Memorandum to the City of Markham Committee of Adjustment

August 29, 2022

File: A/117/22
Address: 4250 19th Avenue, Markham
Applicant: Gaetano Carvelli
Agent: Joseph N. Campitelli Architect Inc. (Joseph Campitelli)
Hearing Date: Wednesday September 7, 2022

CARVELLI FAMILY PROPOSED RESIDENCE

PROPOSED SITE PLAN

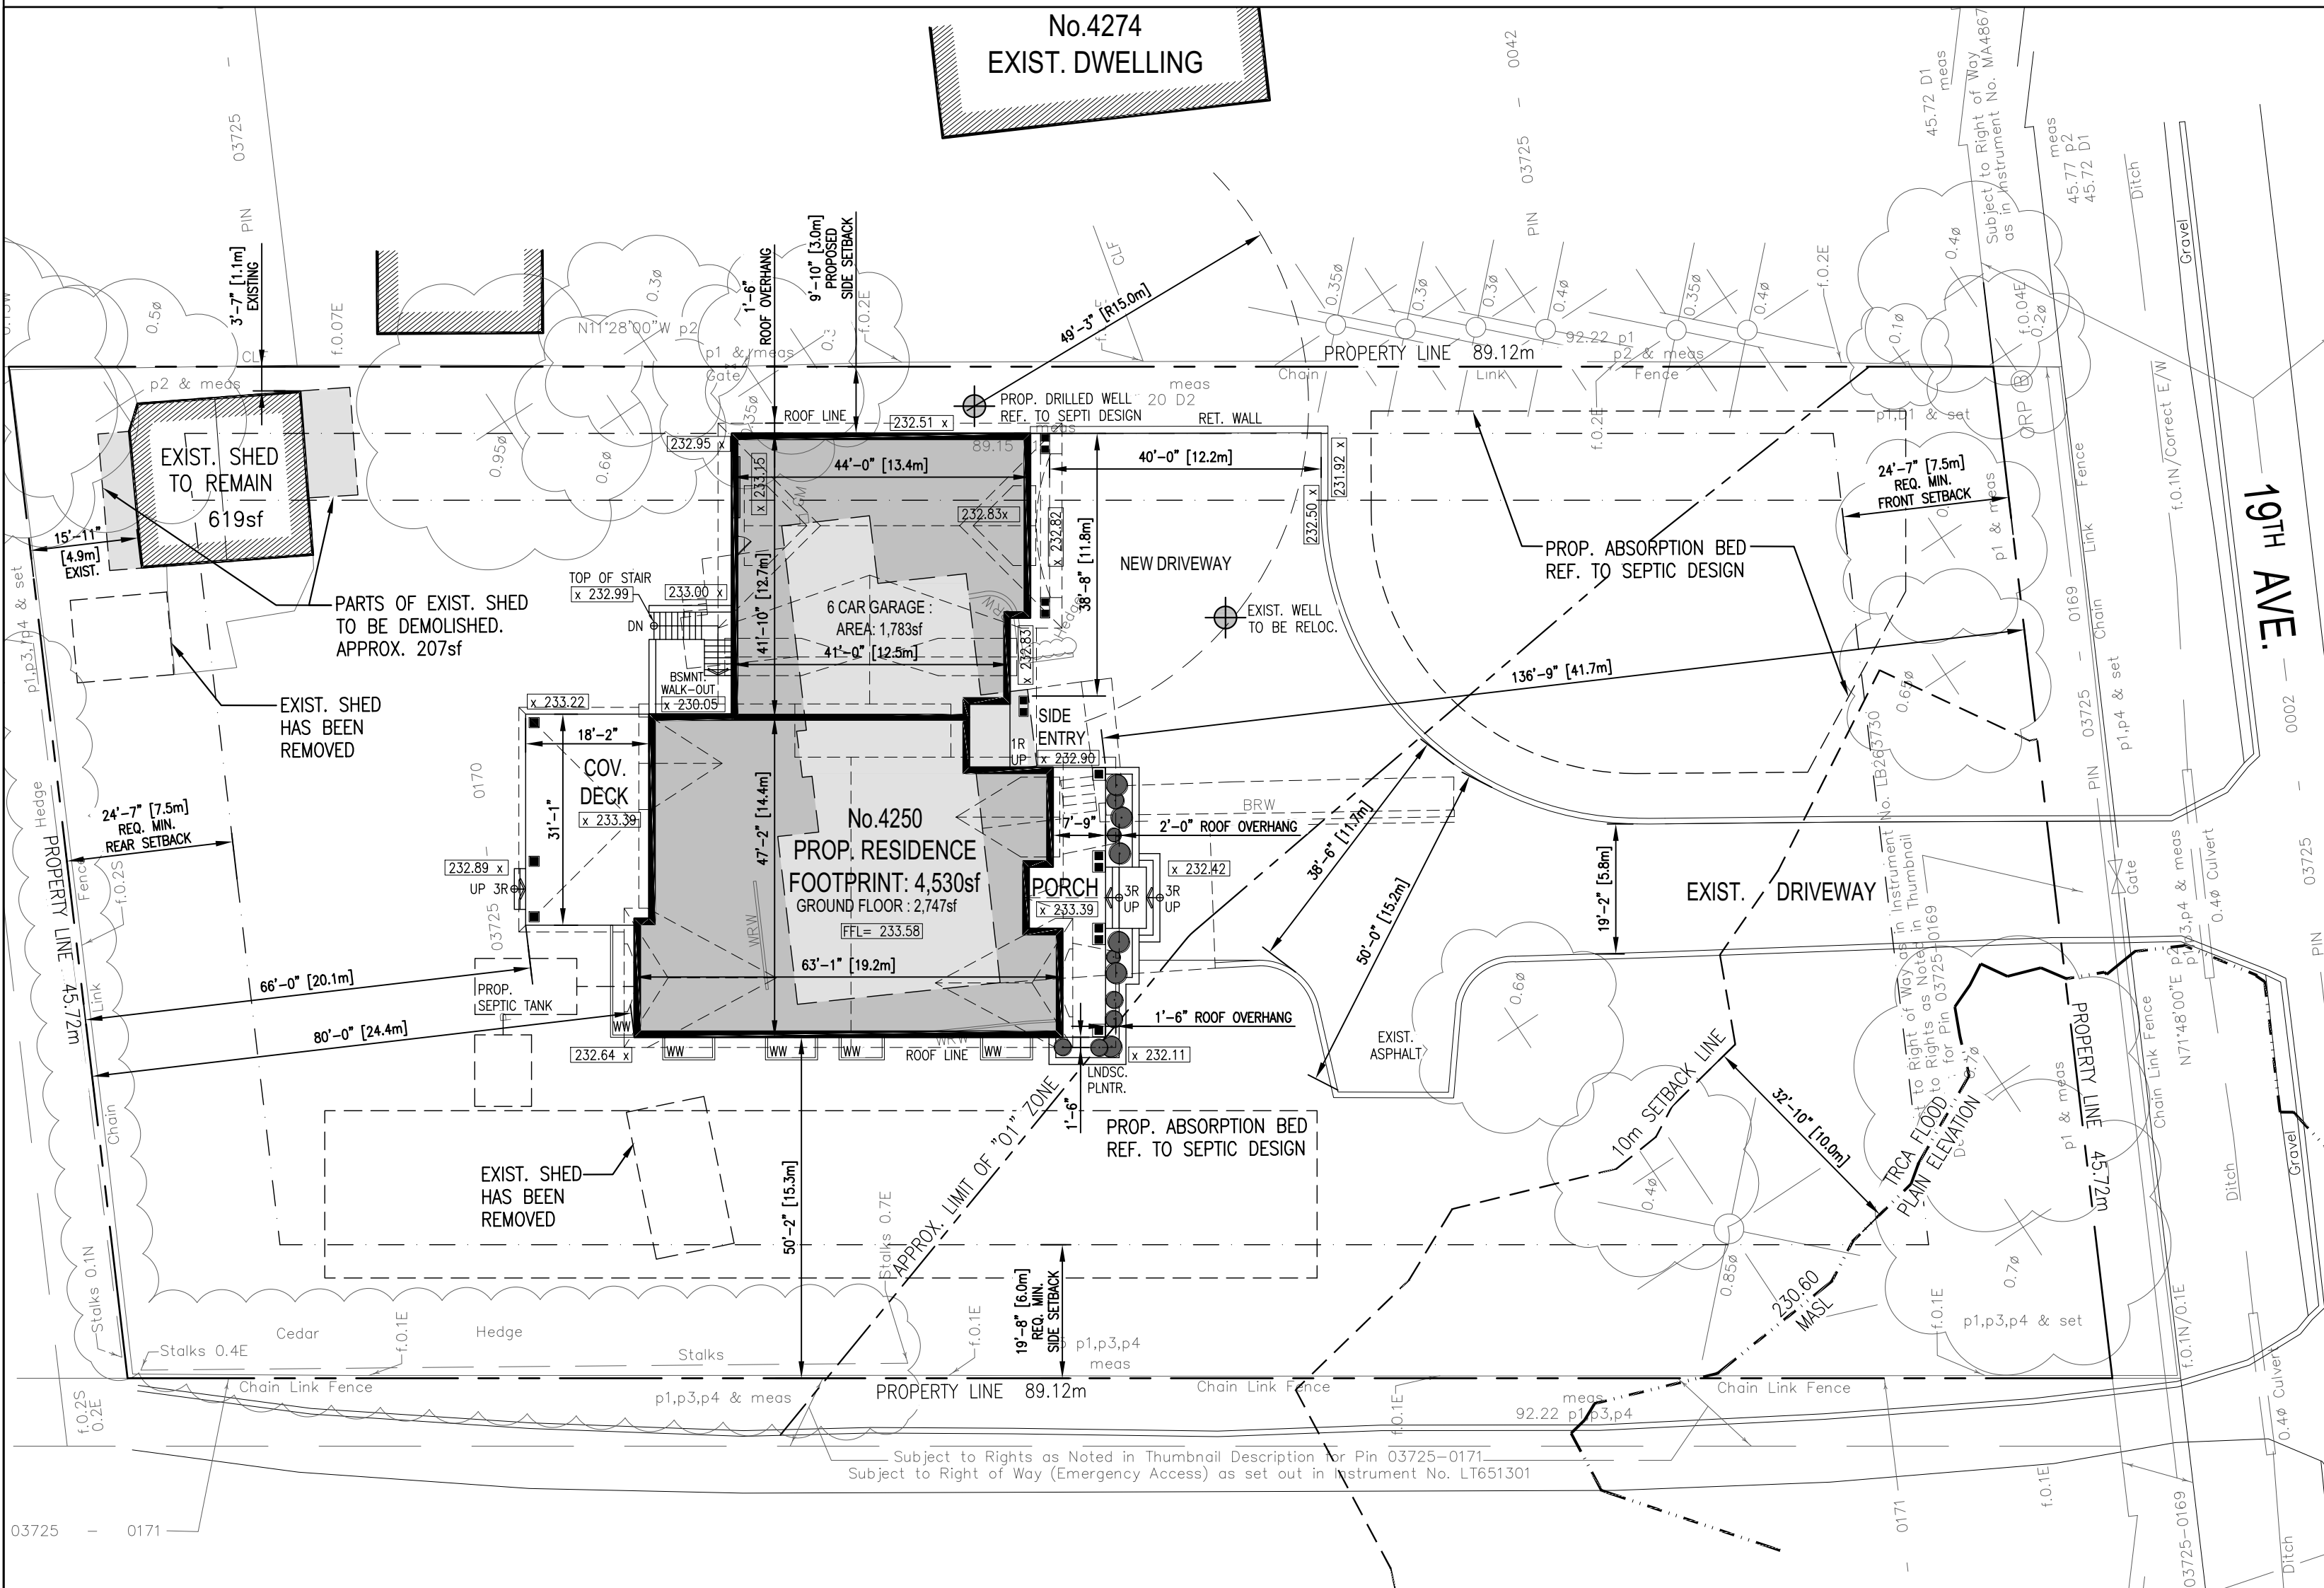
The applicant is requesting a minimum east side yard setback of 3.0 m (9.8 ft) for the two-storey detached dwelling, and a minimum east side yard setback of 1.1 m (3.3 ft) for the accessory building (existing rear shed) whereas a minimum side yard setback of 6.0 m (19.6 ft) is required.

The reduced side yard setback variance is being requested due to the fact that the southwest portion of the subject property being zoned “Open Space One (O1) Zone” which requires the dwelling to be located further northeast and presents a hardship for the property. The requirement to locate the dwelling further north also reduced the space that could be allocated for the backyard. Staff are of the opinion that the requested variance to the east side yard will have minimal impact to the surrounding properties and is generally consistent with the orientation and footprint of dwellings in the area.

The applicant is requesting relief to permit a minimum rear yard setback of 4.9 m (16.0 ft), whereas the By-law requires a minimum rear yard setback of 7.5 m (24.6 ft). This represents a reduction of approximately 2.6 m (8.5 ft.).

The variance is entirely attributed to the existing accessory building (shed). The applicant is proposing to demolish portions of the existing shed which results in an increased rear yard setback from its current state. The proposed rear yard setback from the main dwelling provides a setback of 20.1 m (65.9 ft.) and is generally consistent with the established rear yard setbacks of the dwellings on the same street.

The applicant is requesting a maximum driveway width of 15.2 m (49.9 ft), whereas a maximum driveway width of 12.2 m (40.0 ft) is permitted, which is the equivalent of the garage door width plus 2.0 metres, provided that a minimum 40% soft landscaping is provided in the front yard. This is an increase of 2.0 m (6.6 ft).

Based on the plans submitted with the application, the variance is required due to the existing asphalt vehicle turnaround space to the west of the existing driveway. The proposed widening would apply to the section of the driveway that is well inset from the street. Staff further note that the proposed widening would not require the removal of existing trees and the private driveway will be tapered down to the width of the existing driveway well in advance of the property line. Staff are of the opinion that the requested variance is minor in nature, maintains the general intent of the By-law and would not have significant visual impact from the street.
